DeKalb County Historic Preservation Commission

Staff Report

B. 1606 Emory Road, Ashley McClure. Remove and replace deck and screen porch on the rear of a nonhistoric house. **1247405.**

Sever - de Veer Residence

Site Plan and Zoning Summary -**Proposed**

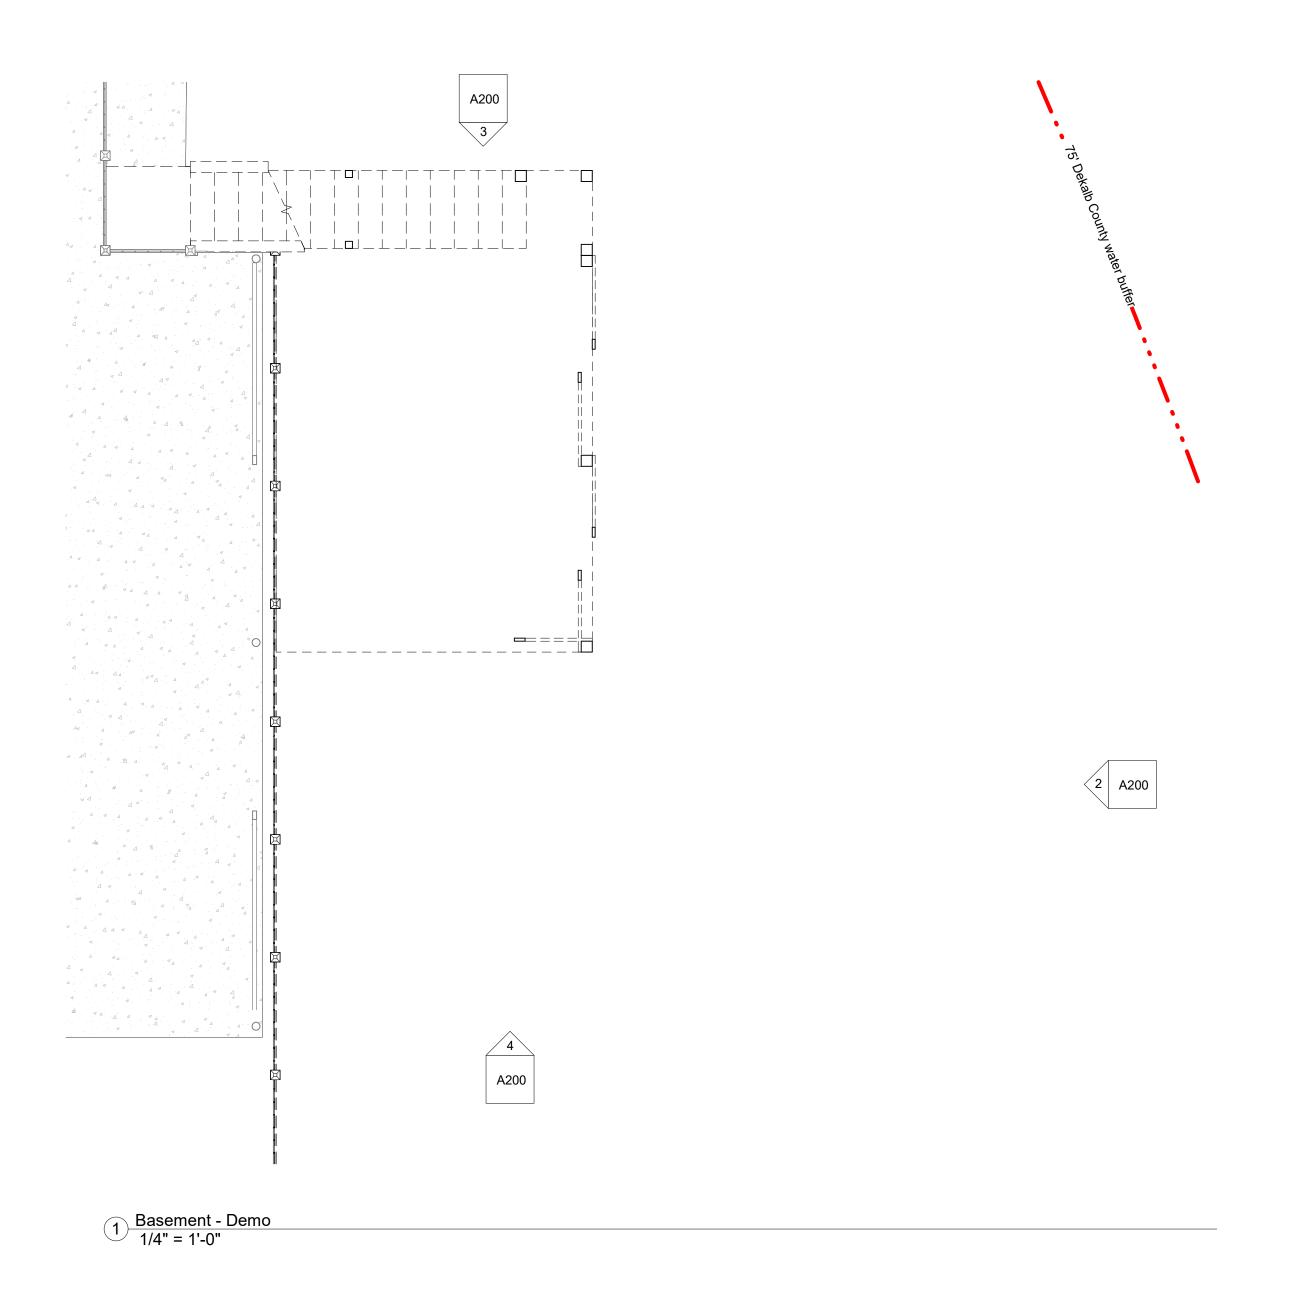
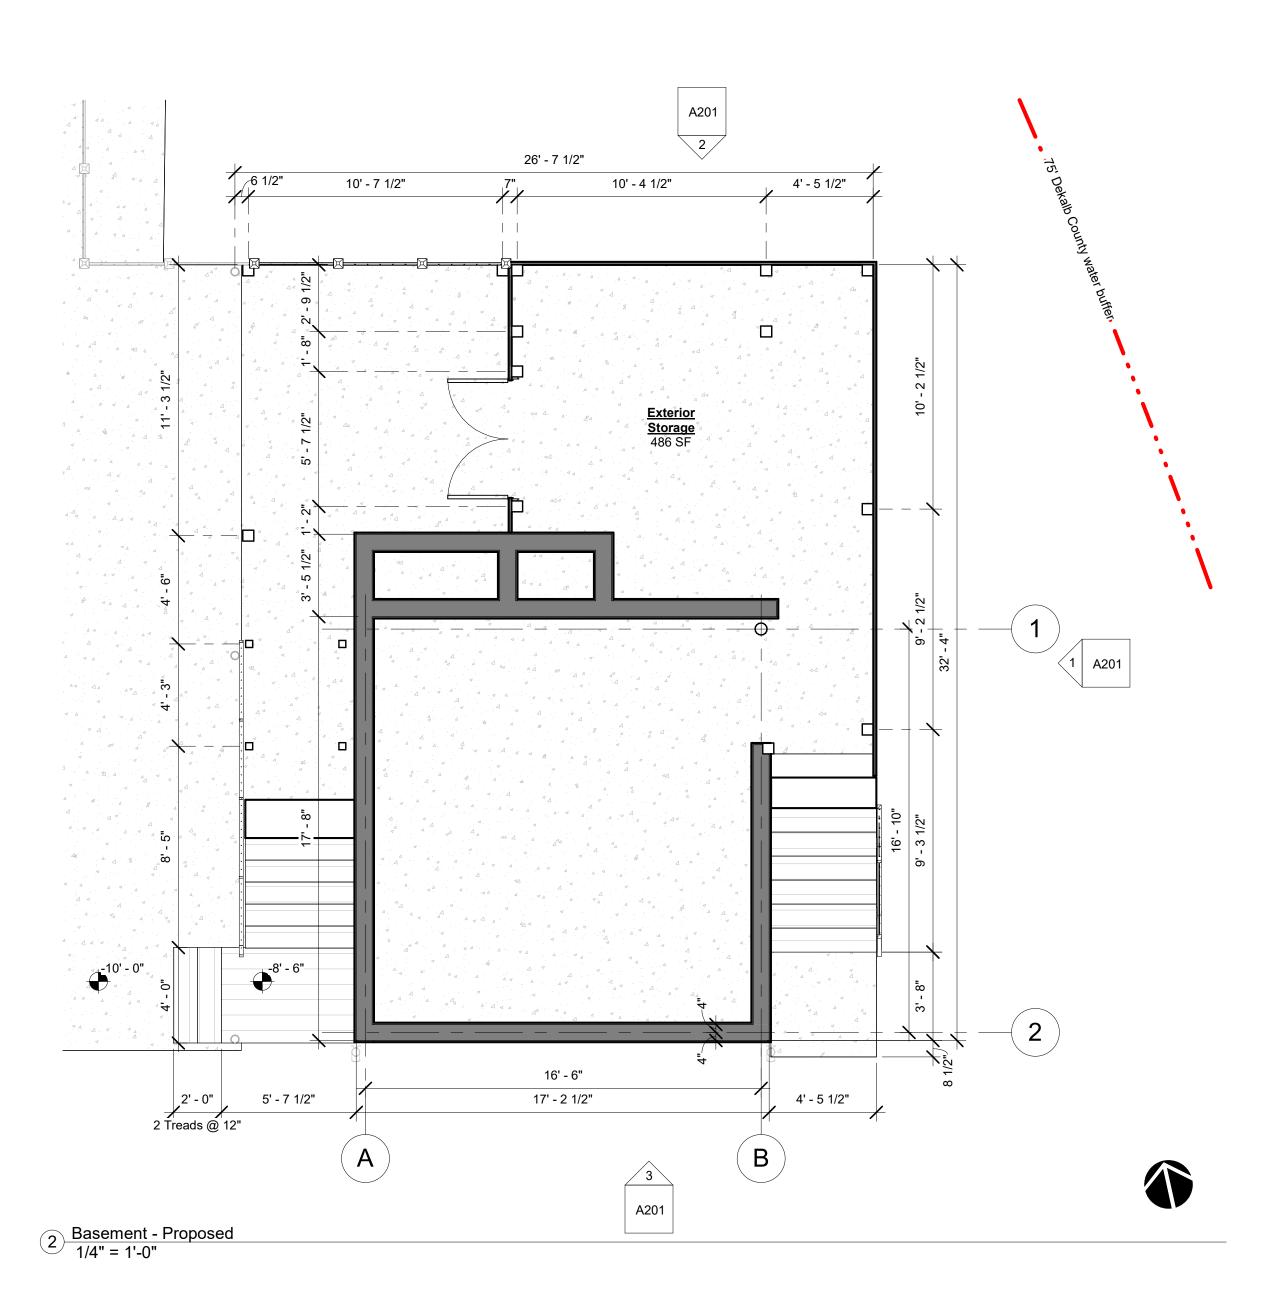
- 1. What is the height of the roof ridge of the house?
- 2. What is the square footage of the existing deck? What is the square footage for the proposed deck?
- 3. Will any trees be removed to accommodate the new deck?

- 1. What is the height of the roof ridge of the house?
 - The existing roof ridge is 17'-7 1/2" as shown on 1/A200, measured from the front door threshold as required in section 5.2.5.B
- 2. What is the square footage of the existing deck? What is the square footage for the proposed deck?
 - The existing deck is 375 sf (including stairs) and the proposed deck (including screen porch and stairs) is 874 sf.
- 3. Will any trees be removed to accommodate the new deck?
 - No trees are proposed to be removed. FYI, I have sent the tree plan to the Dekalb arborist for comment but have not heard back regarding any feedback.

Elevations

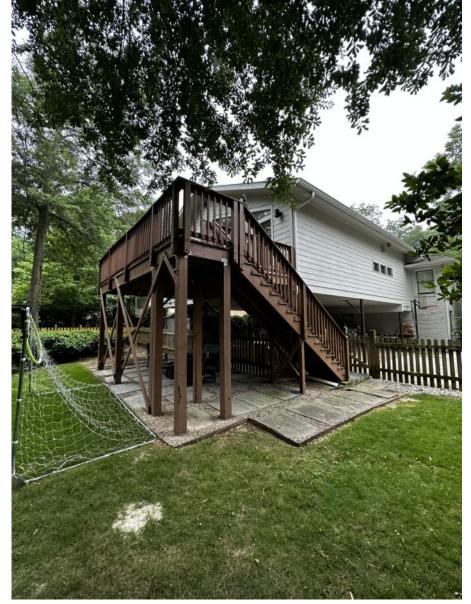
ASK TO BE MOVED TO REGULAR AGENDA. **Approve with Modification**. The construction of the proposed deck and screen porch should be approved with the modification that the shed roof and the metal chimney flue does not surpass the height of the roof ridge of the original structure in accordance with guidelines 7.0, 7.2.2, 7.2.3, 7.2.7, and 7.3.1.
